1300 NE 45TH ST

DESIGN REVIEW BOARD RECOMMENDATIONS

SDCI PROJECT #: 3032085

OPTION 3 - PREFERRED
"GRID"

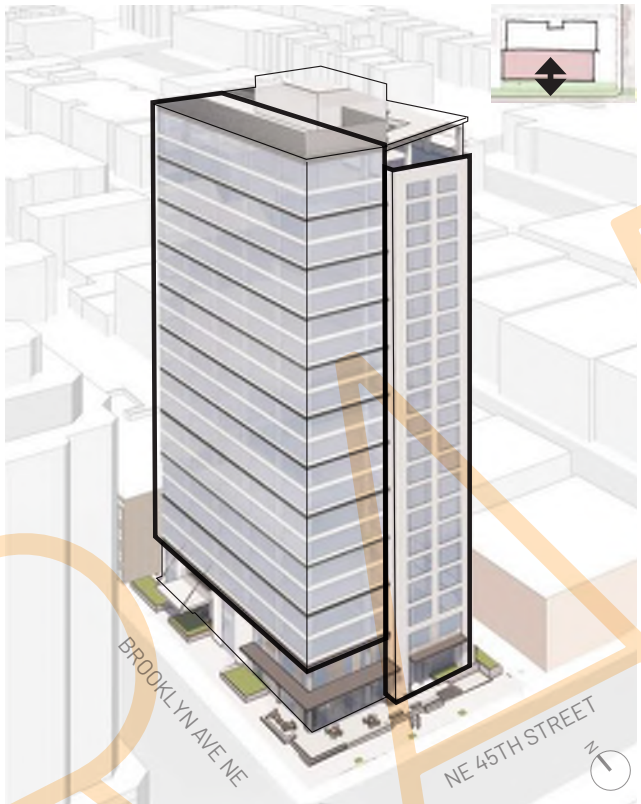
The Board agreed that the three options offered little variation in slab layout or form but **support the preferred massing scheme** (Option 3) and agreed that its simplicity of form and proposed grid and infill expression could become a coherent design scheme that fits well on the site and responds to context. (CS2-D, CS3-1, DC2-A, DC2-2)

SITE PLAN

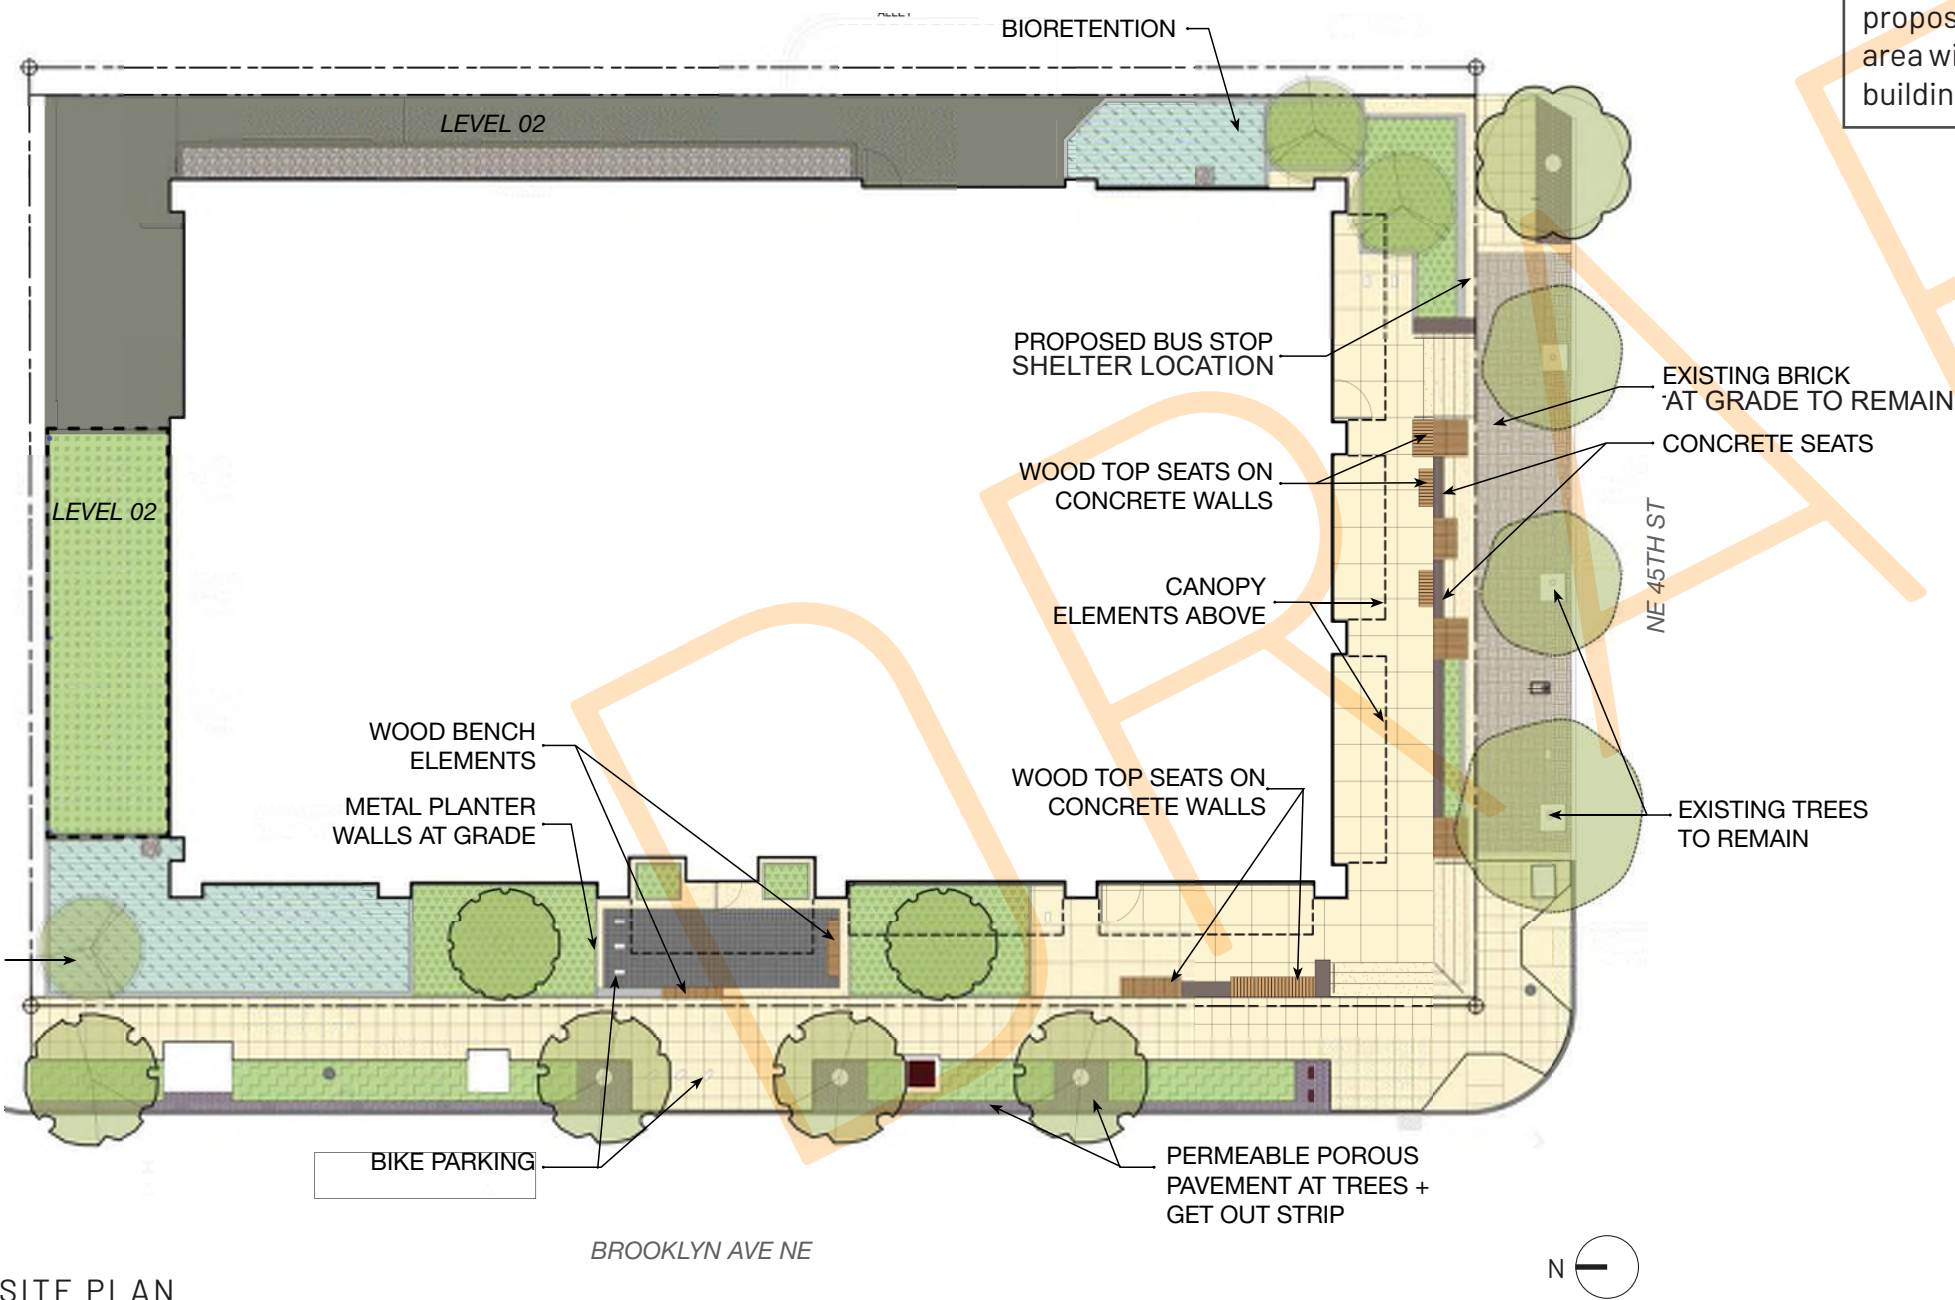
The Board discussed the **relative size of the street-level setbacks on both 45th Street and Roosevelt Avenue**, and considered the possibility of weighting the distribution of setback distances in favor of 45th Street, agreeing that a departure could be considered if a strong rationale were offered. (DC3-1, PL1-B-3)
- 3e

The Board had questions about the **notch in the ground floor area at the north property line** and requested complete explanatory drawings for the next meeting.

Response:
The proposed setbacks along the two street frontages are similar, but the design of each is unique, related to the site context. The NE 45th St. setback is focused on pedestrian engagement with its plinth acting as a front porch for the building. The area within Brooklyn Ave. NE frontage is heavily landscaped in keeping with the Green street guidelines, this is also appropriate because this street has a “residential” character.

The notch is in line with the tower footprint above, it is setback from the primary facade and proposed with a textured concrete wall related to the masonry building on the adjacent property. There is a large bio-retention planter in front of the area, the proposed design acts as a backdrop to this landscaping. The increased setback at this area will also expose more of the existing south masonry wall of the adjacent residential building.

DRB - ALLEY ENTRY

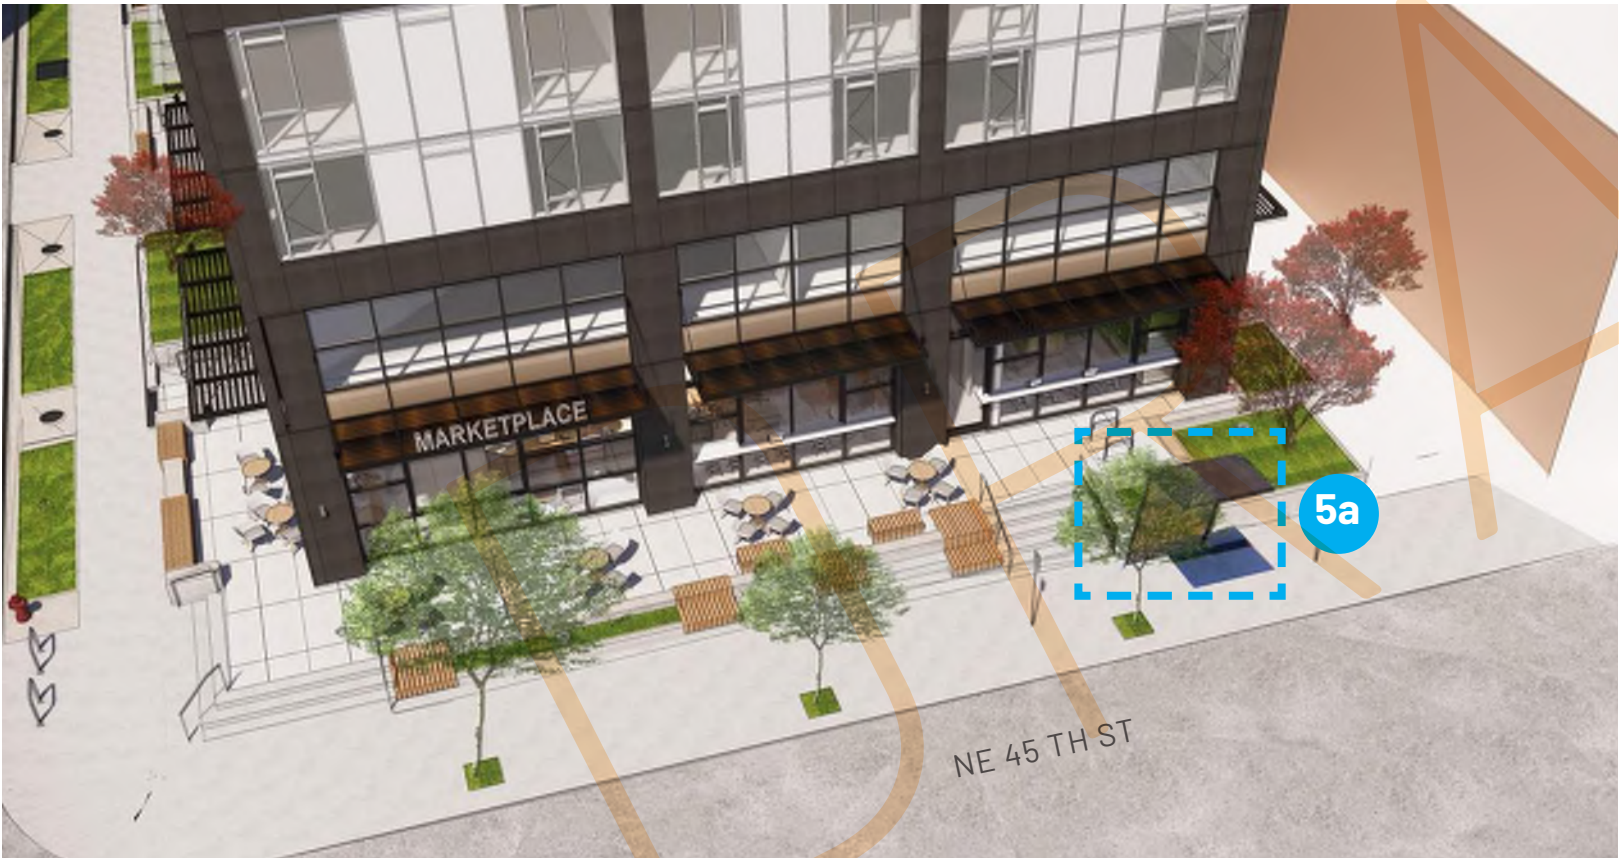
4a The Board, echoing public comment, noted the importance of alleys for pedestrian circulation in the University District and provided guidance to **carefully consider the pedestrian experience of the entire alley and the 45th Street corner in particular.** This care should be demonstrated in the site planning, lighting and facade composition of all areas in the adjacent to the alley. (PL3-1, PL3-A)

Response:
The proposed design softens the entry to the alley with low raised planters. These provide a green “bookend” for the east side of the plaza while making this alley entry more inviting.

BUS STOP SHELTER - STREET VIEW

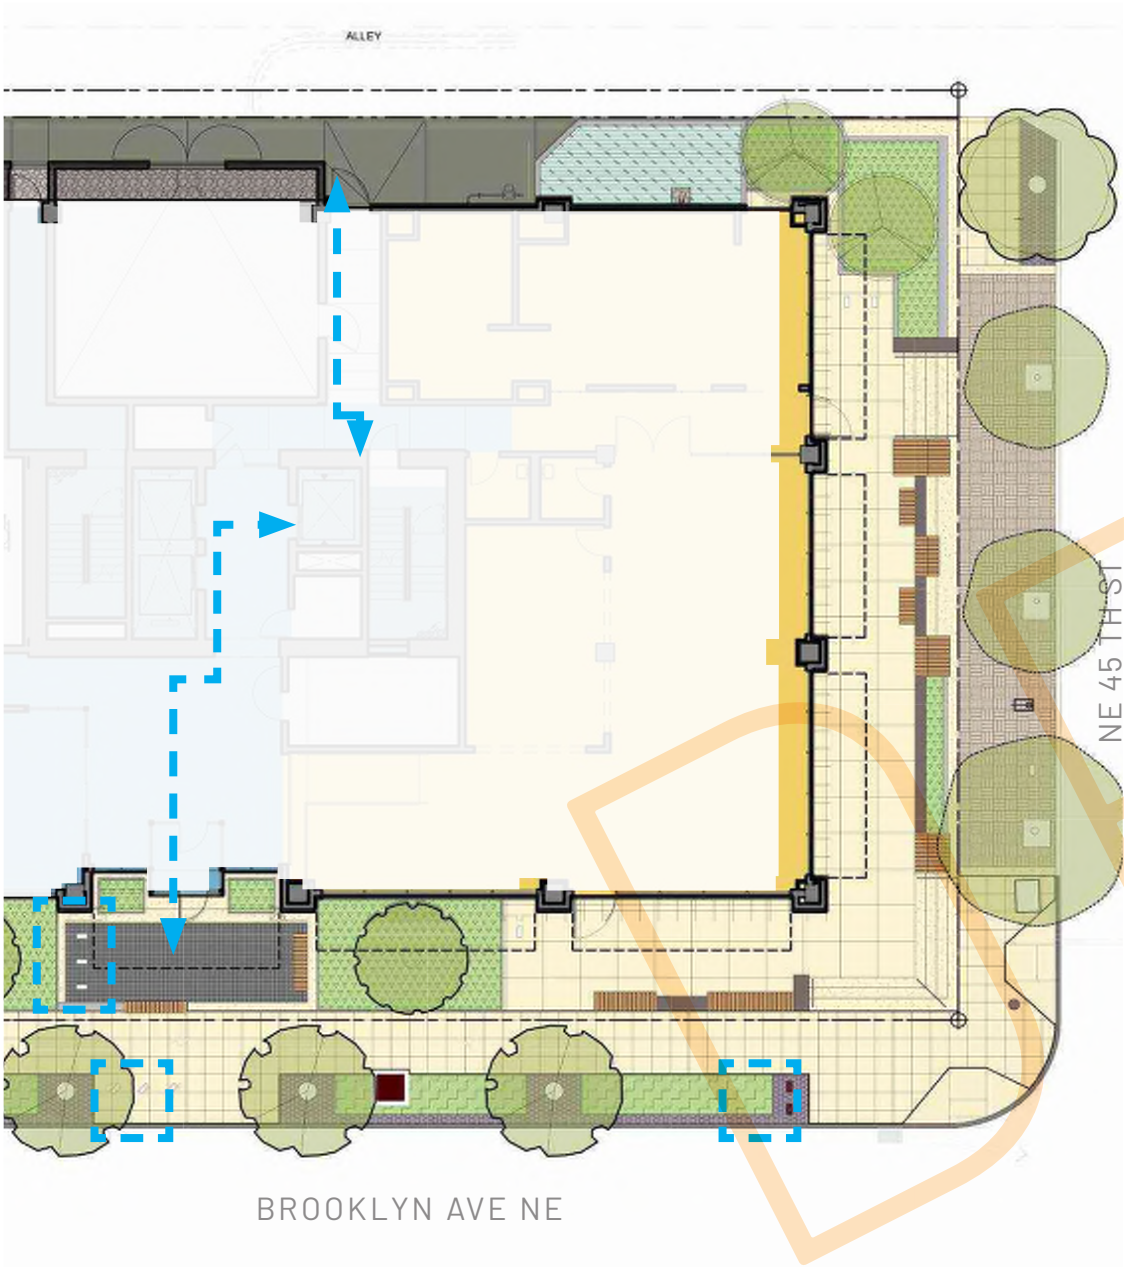
The Board, echoing public comment, pointed out the level of use of the **existing bus stop on 45th street** and that the volume is only likely to grow. The Board agreed that it would be critically important to design this edge to support this use, and incorporating (ideally in consultation with Metro) complementary pedestrian amenities. (PL4-C, PL4-2)

Response:
Simple glass and metal bus stop shelter are being coordinated with SPU.

AXONOMETRIC - CORNER

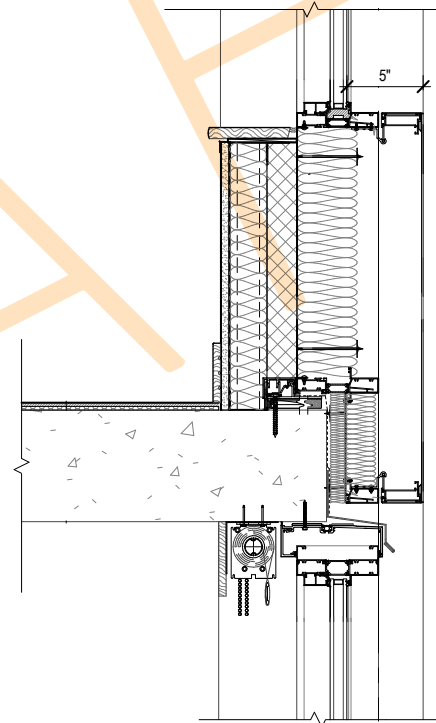
The Board supported the simplicity of the grid expression but encouraged the design team to explore options that incorporate greater compositional flexibility, including variation in the location of open-space voids and the expression of the gasket element. (DC4-A, DC2-B, DC22, DC2-6)
- 6b

The Board agreed that the magnitude of the plane-change between the frame and infill panel was critically important to the design concept and encouraged the design team to maximize that distance.

Response:
The open space voids are related to the location of the floor-level common rooms for the building occupants. These spaces will have preserved views because this project lies at the east edge of the U-District up-zone area. We have introduced variation in the grid infill through the placement of glazing and cladding.

We are working closely with the window wall manufacturer to provide a cleanly expressed grid. The proposed system will have a 5-1/2" offset from the infill glass to the face of the grid cladding, this is what was proposed during the EDG meeting.

PROPOSED DESIGN

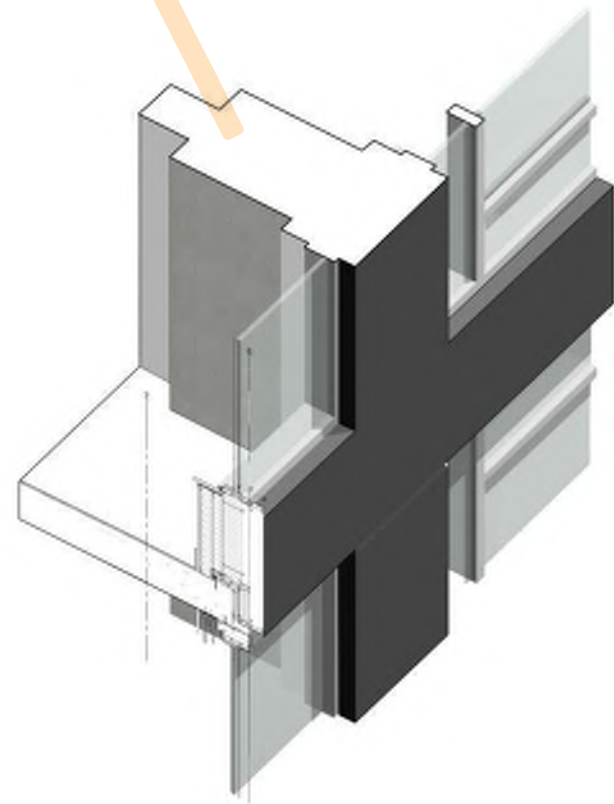
6c The Board noted the **strong design characteristics evidenced in the precedent images** provided throughout the packet and encouraged the design team to strive for this level of work.

Response:
The proposed expressed grid with an offset to the main body of the building, incorporating a contrast in color and material should achieve this goal.
